At our Phase 1 informal consultation in June 2022, we presented our initial proposals and thoughts on how the site could be designed based on a preliminary understanding of the environmental constraints and prior to engagement with local residents. This initial design is shown below.

Changes made as a result of feedback and survey results

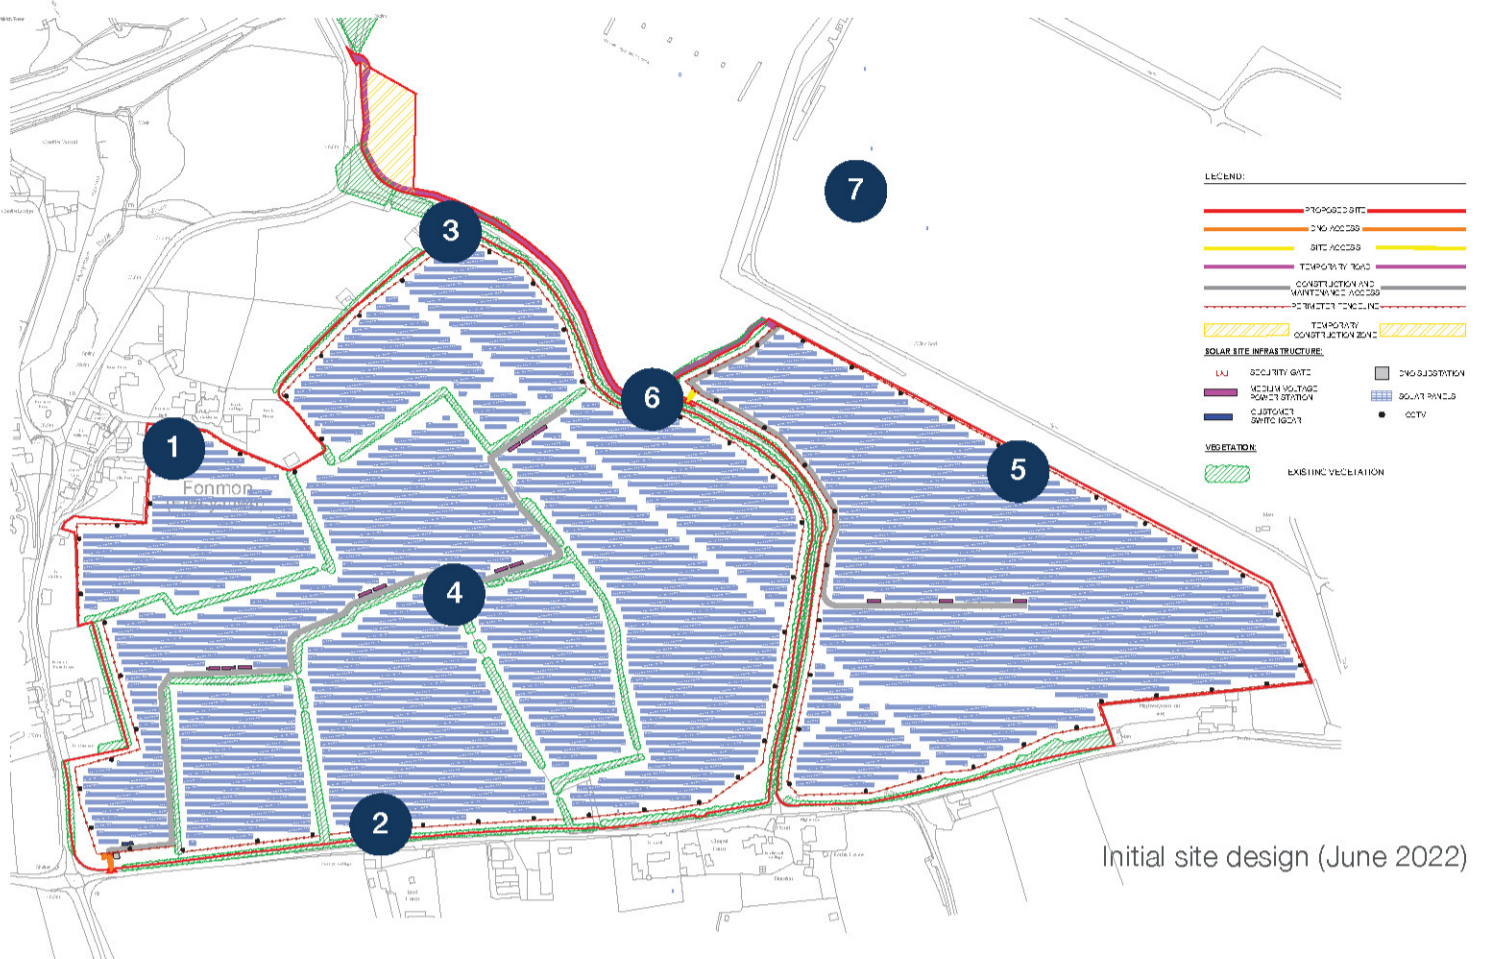
- 1 This area will remain free from panels to reduce impact on views from homes, and on listed buildings in Fonmon.
- 2 Areas along the southern boundary adjacent to the residential properties on Port Road (from Bird Farm to Highmead) will also be free of panels to reduce impact on views from nearby homes to the south.

- 3 This area to the north of the site will also have panels pulled back to reduce visual impact on an adjacent property.
- 4 The existing hedgerows within and surrounding the site will be restored and/or reinforced to address potential for visual impact across the site from multiple viewpoints.

- 5 A minimum 15m offset from the existing public right of way along the eastern boundary of the site is required to maintain openness. In addition, further screening will be provided along the eastern boundary to reduce potential glint and glare impacts on the air traffic control tower at Cardiff Airport.

- 6 The access point has been amended slightly following discussion with the local authority Highways team.
- 7 Change in orientation of the panels to alleviate concerns from Cardiff Airport relating to glint and glare.
